RESPONSE TO REQUEST FOR ADDITIONAL INFORMATION

APR1400 Design Certification

Docket No. 52-046

RAI No.: 152-8006
SRP Section: 09.05.04 – Emergency Diesel Engine Fuel Oil Storage and Transfer System
Application Section: 09.05.04
Date of RAI Issue: 08/10/2015

Figure 9.5.4-1 Diesel Fuel Oil Transfer System Flow Diagram

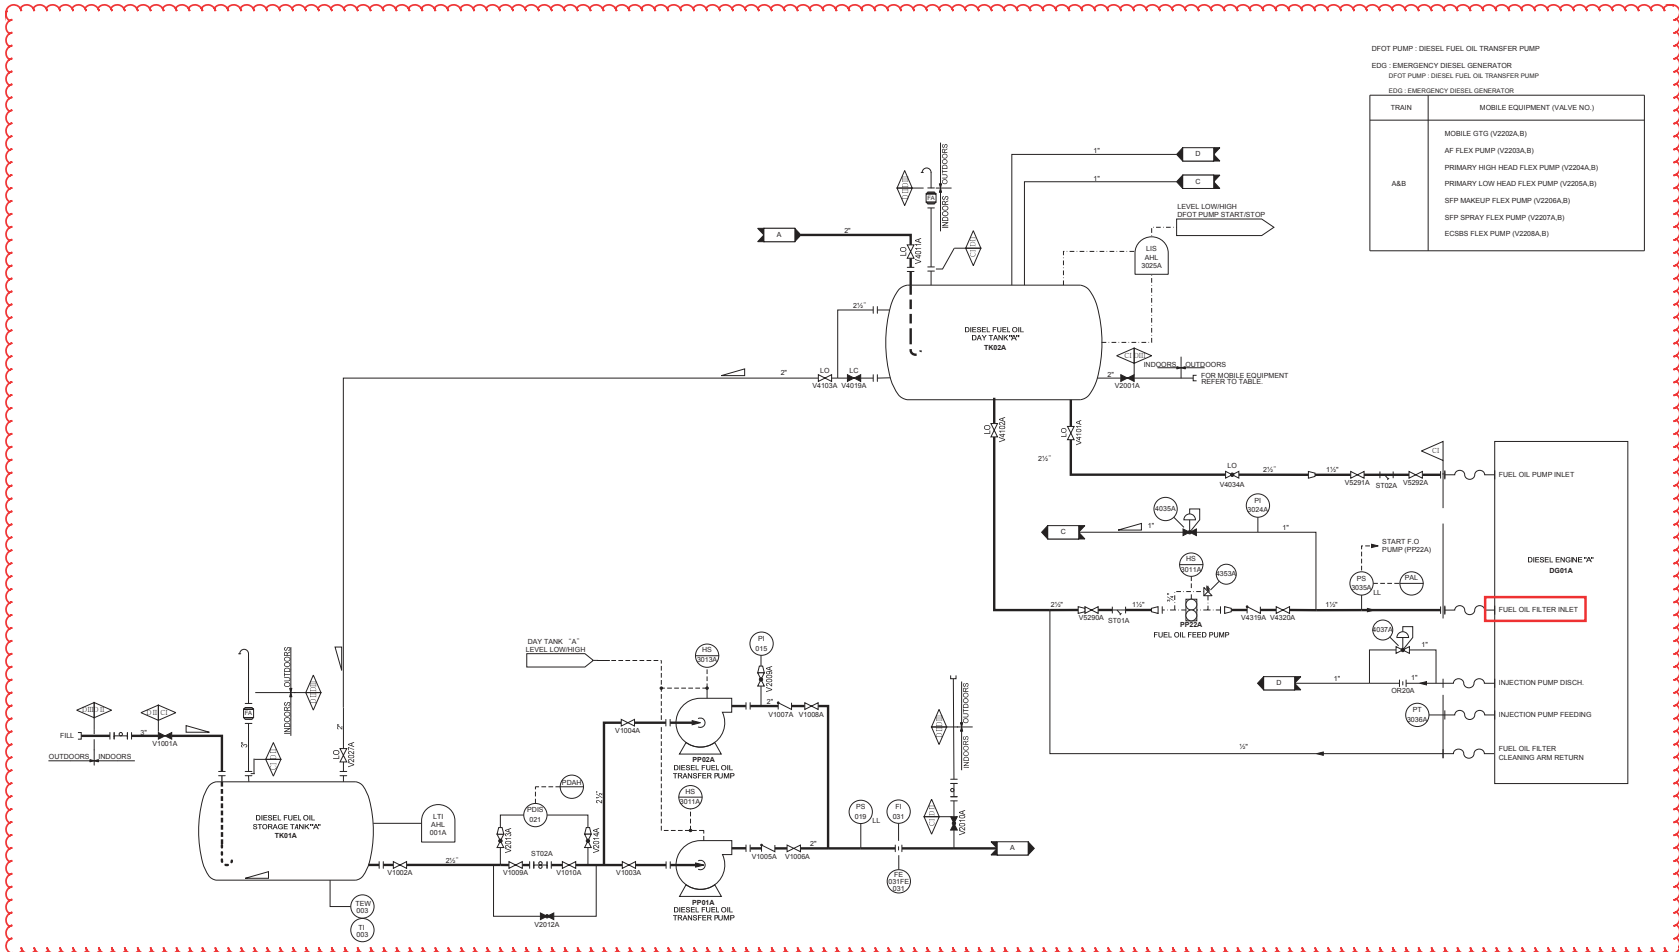
The staff is unable to find any description of these filters in DCD Tier 2, Section 9.5.4 or their location in Figure 9.5.4-1.

The applicant is requested to define the fuel oil filters and their use, and update the DCD and Figure 9.5.4-1 accordingly.

The function of the fuel oil filter is to filter fuel oil for each diesel engine. The fuel oil filter is installed in the diesel engine enclosure, and located between the engine-driven fuel oil feed pump and the engine.

DCD Tier 2, Figure 9.5.4-1 will be revised to show the filter location.

DCD Tier 2, Subsection 9.5.4.2.2, 9.5.4.6, and Figure 9.5.4-1 will be revised as indicated on the attached markup.

Figure 9.5.4-1 Diesel Fuel Oil Transfer System Flow Diagram

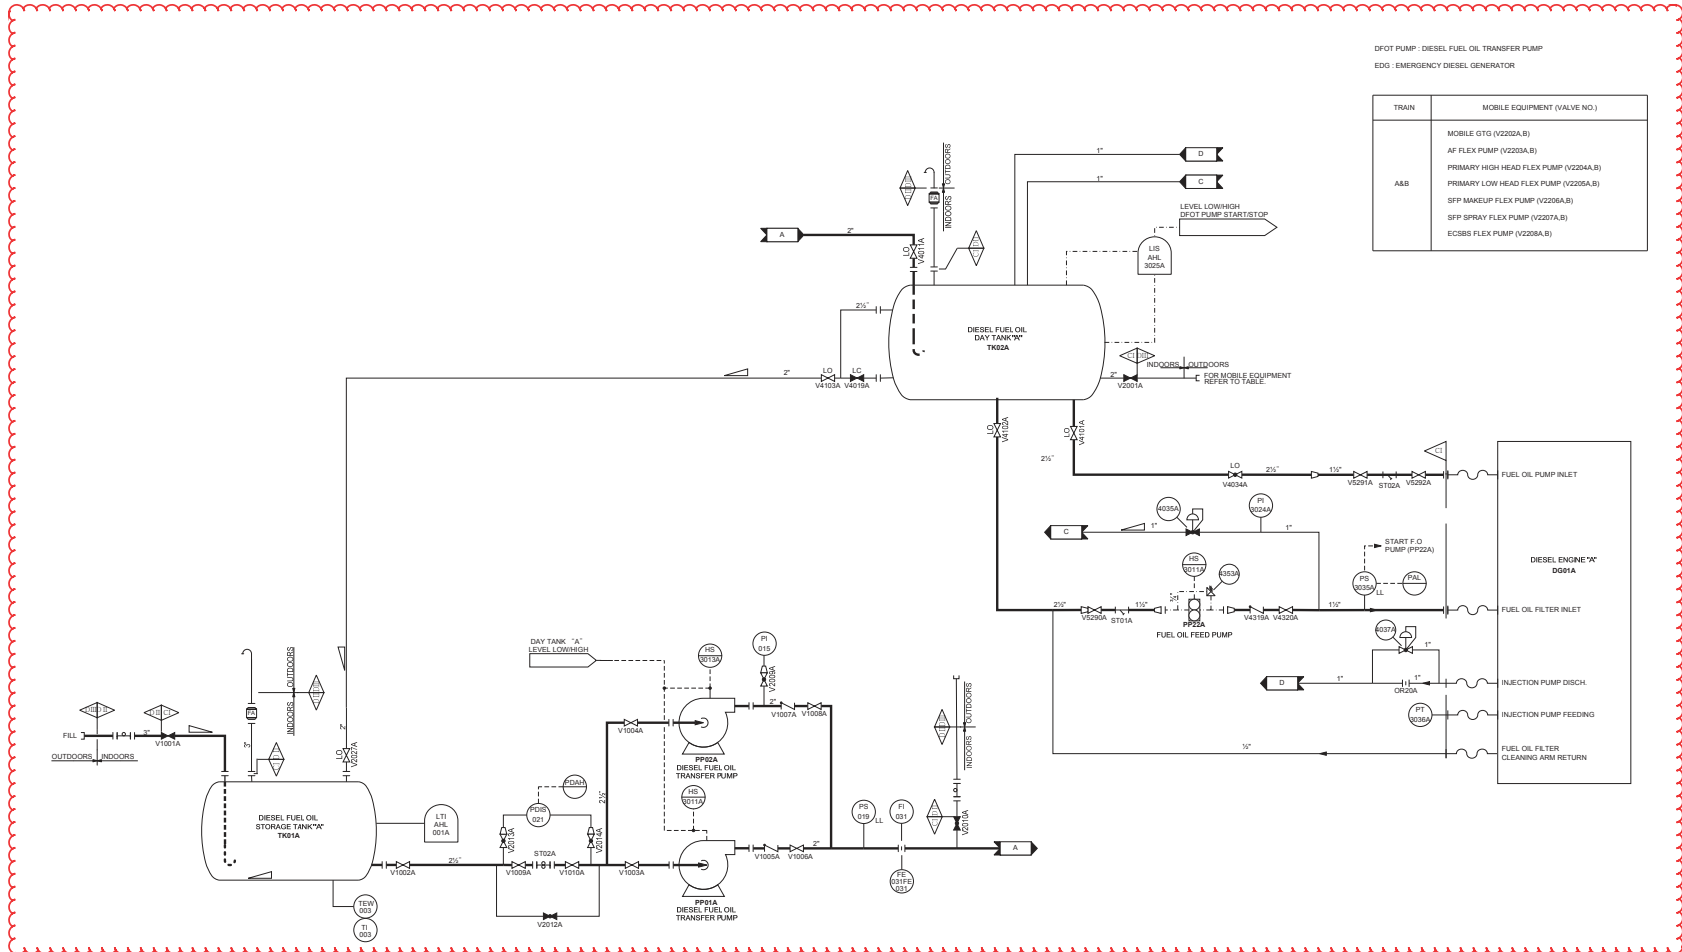
DCD Tier 2, Figure 9.5.4-1 shows two main inlet and two outlet connections to the diesel fuel oil day tank for supplying diesel fuel to emergency diesel generator (EDG) engine and EDG engine auxiliary skid.

The staff is unable to find any description of the “EDG “A” engine aux skid” referenced on Figure 9.5.4-1 to verify that GDC 5 is met.

The applicant is requested to define the aux skid connection, and update the DCD accordingly.

DCD Tier 2, Subsection 4.5.4.1.f states that “Each EDEFOS is designated as safety related and is not shared by other diesel generators.” Each EDG of APR1400 DC has an independent EDEFOS.

DCD Tier 2, Figure 9.5.4-1 will be revised to show the route from the diesel fuel oil storage tank “A” to the emergency diesel engine “A”. Train A is indicated as being representative of trains B, C, and D.

DCD Tier 2, Figure 9.5.4-1 will be revised as indicated on the attached markup.

Figure 2.6.2-1 Emergency Diesel Generator Mechanical System

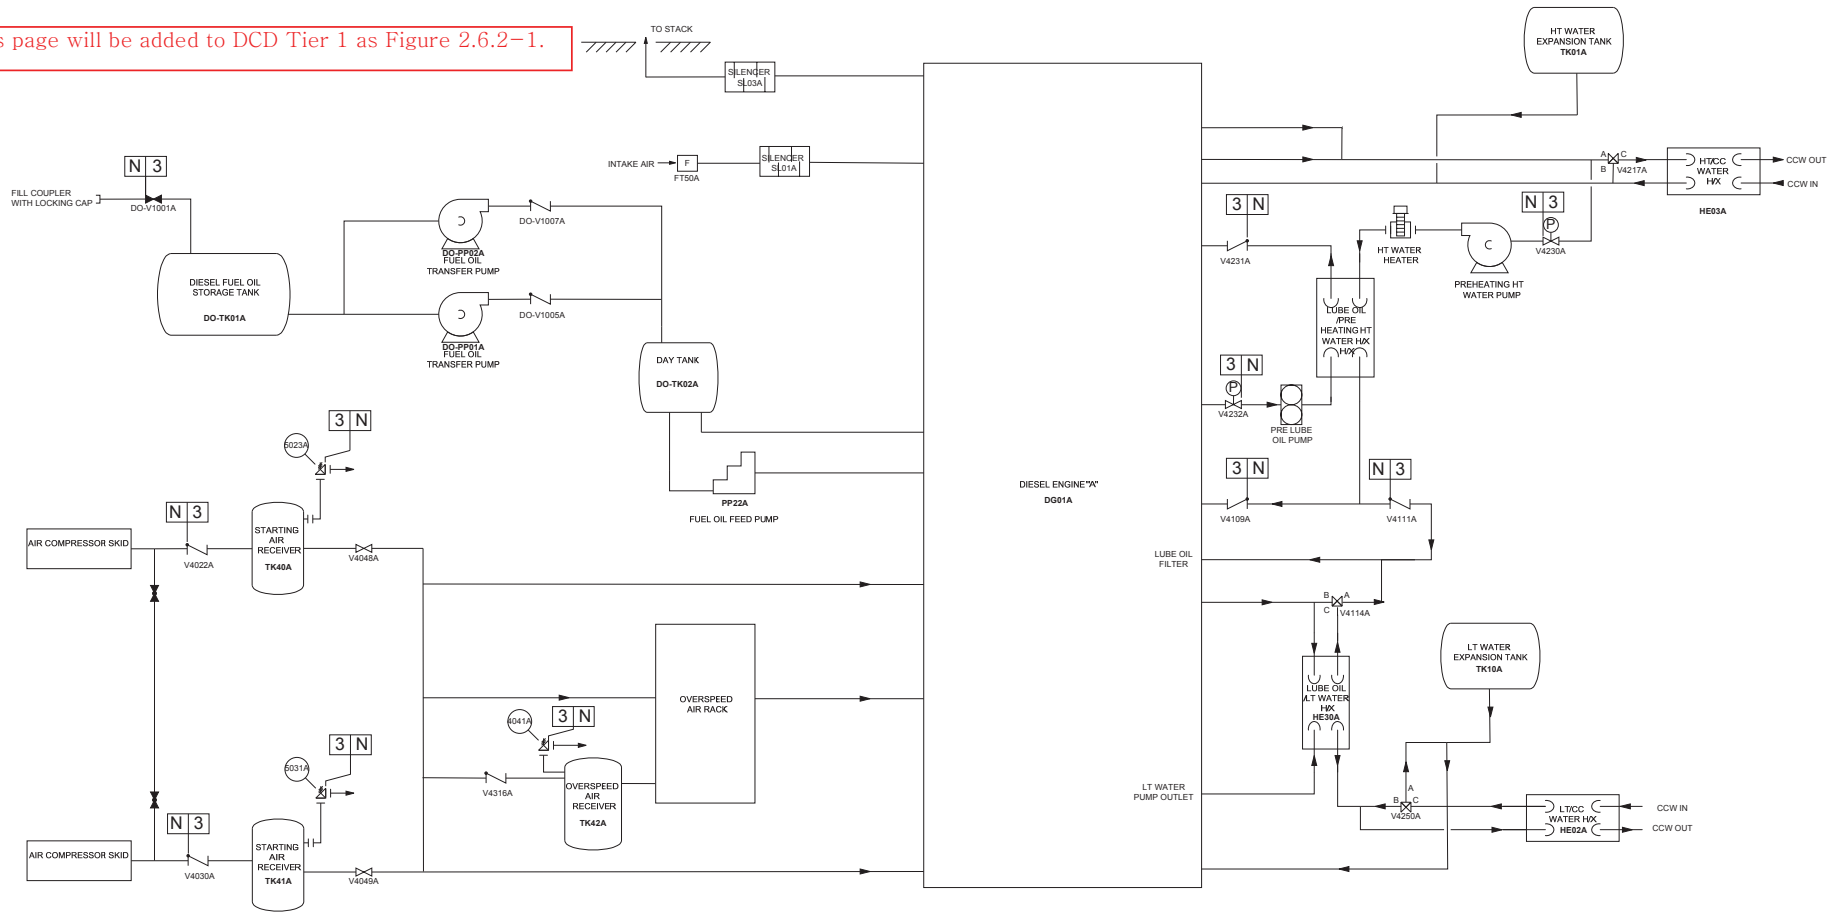
The staff is unclear how the acceptance criteria to verify as-built functional arrangement can be achieved with the current Tier 1 content. In addition, Tier 1 information does not contain any figures showing the functional arrangement to inspect or verify. (This RAI also applies to other EDG support system Section 9.5.5, 9.5.6, 9.5.7, and 9.5.8 containing similar content)

The applicant is requested to provide functional arrangement information and/or the corresponding figures to allow acceptable closure of the ITAAC design commitment.

DCD Tier 1, Subsection 2.6.2.1 defines the EDG support system. Items listed in DCD Tier 1, Tables 2.6.2-1 and 2.6.2-2 are essential portions of the EDG support system to provide its safety function. In addition, a schematic flow diagram of the EDG support system will be added to DCD Tier 1, Subsection 2.6.2 as Figure 2.6.2-1. Also, DCD Tier 1, Table 2.6.2-1 and 2.6.2-2 will be revised.

DCD Tier 1, Figure 2.6.2-1 will be added as indicated on the attached markup.
